Project		Variant [No Variations]	
Title Block Diagram		Rev.	
Size A3	Date 2/18/2026 2:57:40 PM	Sheet 1/20

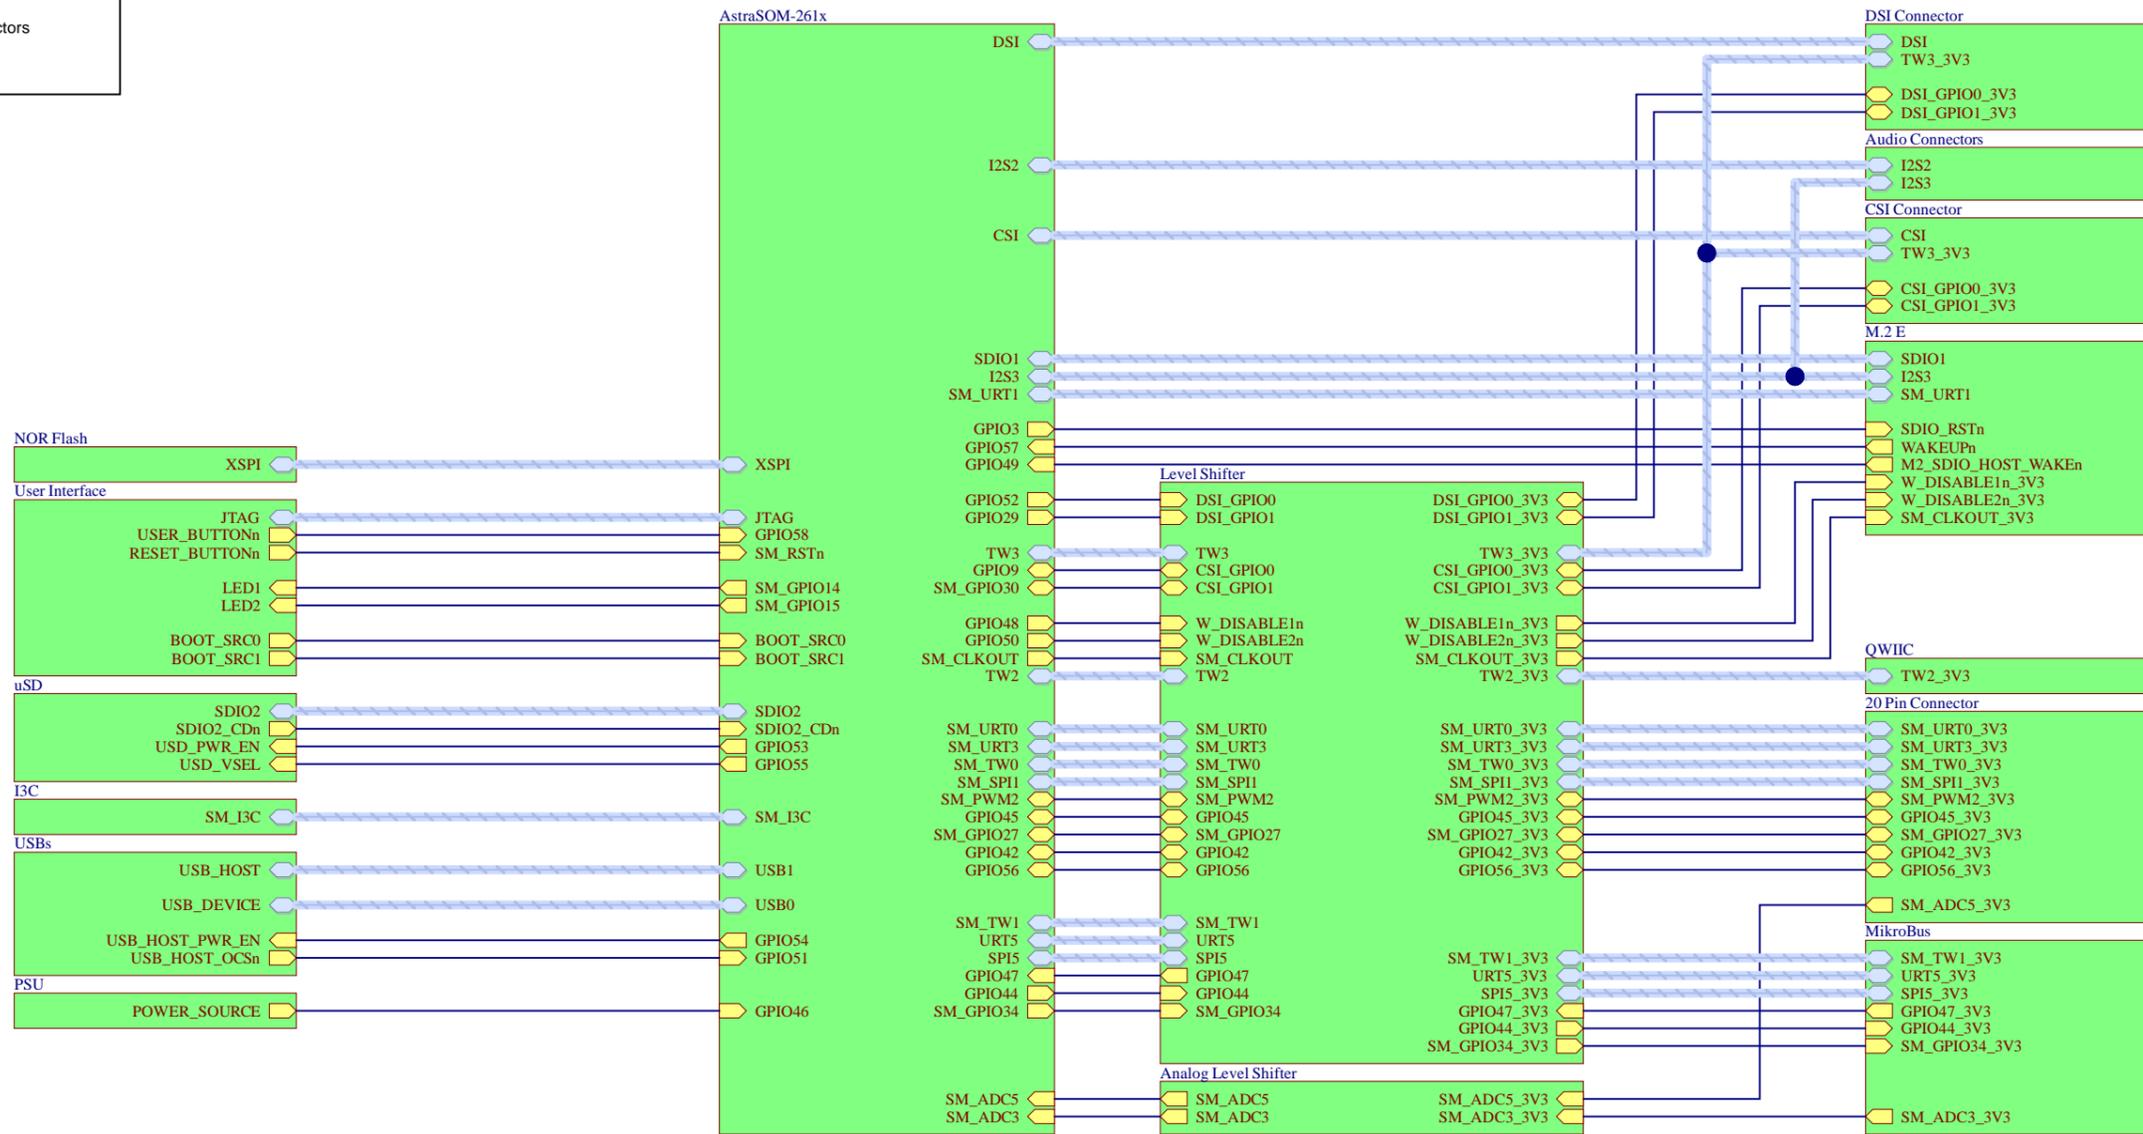
A0	Initial release
A1	- J1 changed to top contact - D8 changed
B0	- logos updated - J4 (I2S2) connector added - GPIO6 assignment changed to GPIO47 - GPIO7 assignment changed to GPIO46 - GPIO11 assignment changed to GPIO44 - JP1-JP4 added - J14 (I2S3) connector added - JTAG connector moved by 0.5mm - SM_ADC13 and SM_ADC15 exchanged - J15 (DSI) connector added - Soldermask changed to white - TP46 - TP49 added - Significant rerouting around DSI / CSI connectors - Design rules changed to 0.1mm / 0.1mm - J8's 3D model updated - 3V3 power plane moved to L2
